In response to the Official Action dated March 8th 2007 (for which a three-month extension of time is respectfully requested), please amend the above-identified application as follows:

Appl. No. 10/533,749
Amdt. Dated 9/5/2007
Reply to Office Action of 3/8/2007

Annotated Sheet Showing Changes

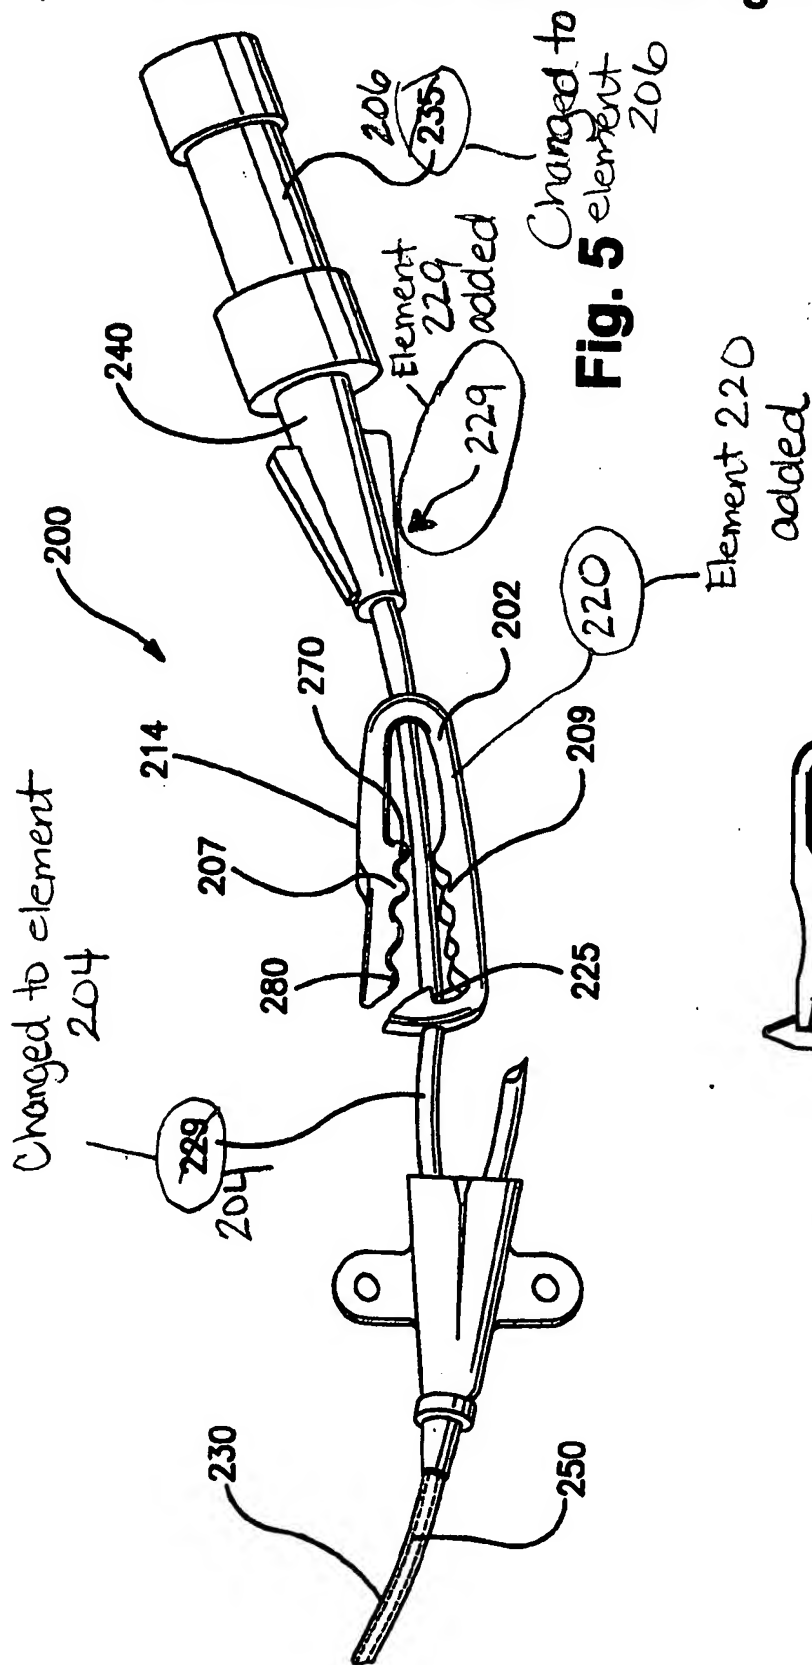
The attached sheets of drawings include changes to Fig. 5 and Fig. 7. The first sheet, which includes Figures 5-6, replaces the original sheet including Figures 5-6. In Figure 5, element 229 has been changed to 204, element 270 has been changed to 208, element 235 has been changed to 206, and previously omitted element 220 has been added.
